1992 - 1993 Corvette: Service Bulletin: Cracks/Damage to Cowl Surface

Subject: CRACKS OR DAMAGE TO COWL SURFACE

Model and Year: 1992-93 CORVETTE WITH RPO LT1 ENGINES ONLY

Bulletin Number: 93-134-10

FIGURE 1

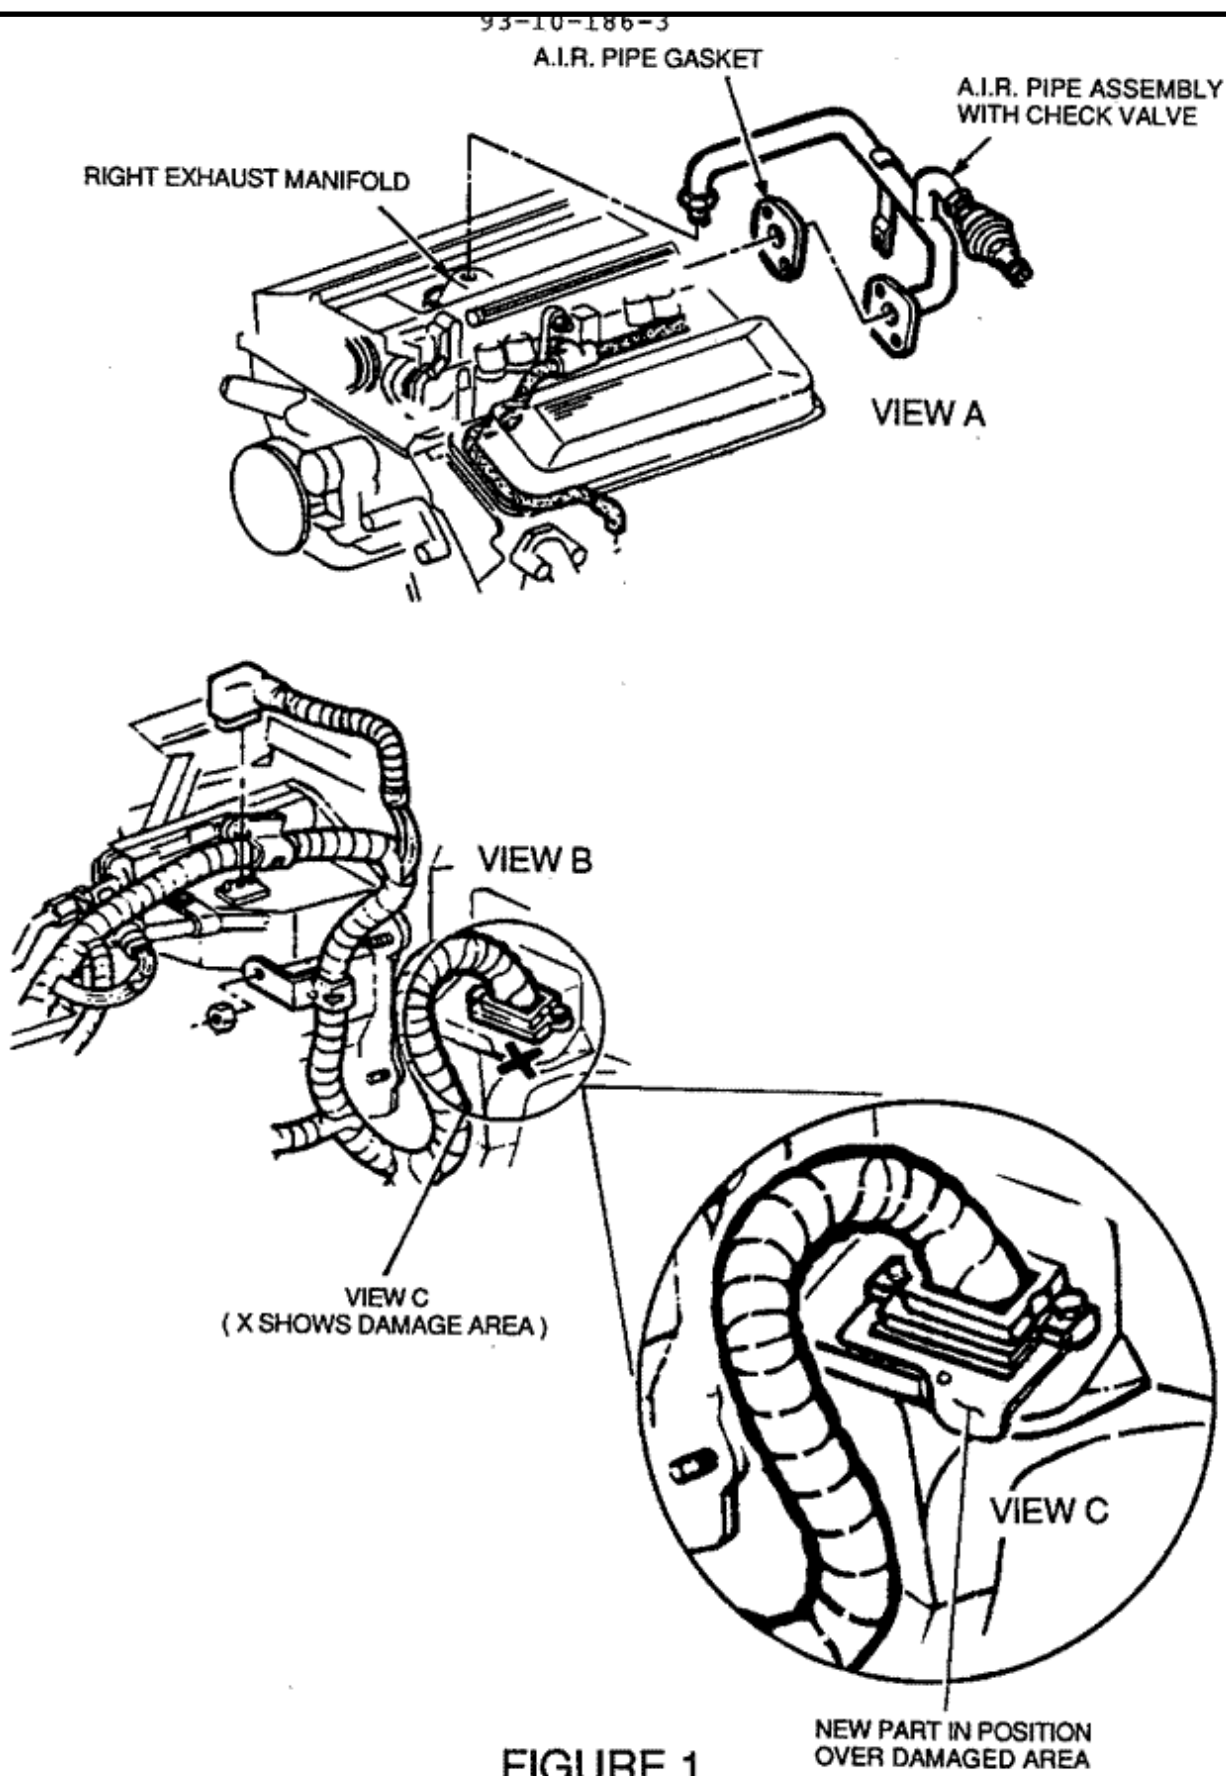
Some 1992-93 Y-cars with LT1 engines may have cracks or damage to the cowl surface:

- Behind the right cylinder head, - Below the wiring harness connector.

Rear of engine may contact the cowl surface when removing transmission or engine from vehicle.

4. Remove right side A.I.R. pipe from engine (See View A);
 - a. Remove nut at exhaust manifold, use 22 mm "crow foot" wrench.
 - b. Loosen bolt on rear of head, using long 9/16" open end wrench.

- c. Remove bolts on rear of intake manifold, use 10 mm 1/4" drive socket and flex extension.
 - d. Remove hose and plastic clamp from check valve.
5. Clean damaged area (See View B) with a wax and grease remover and use V.O.C. approved materials where required.

6. Apply enough seam sealing material to fill or cover the damaged area. Paddle material into place, if required.
7. Loosen the harness connector attaching bolts, position GM P/N 10231336 - Spacer, over the damaged area and under the attaching bolt heads and tighten the attaching bolts. The spacer has slots to aid in installation (See View C).
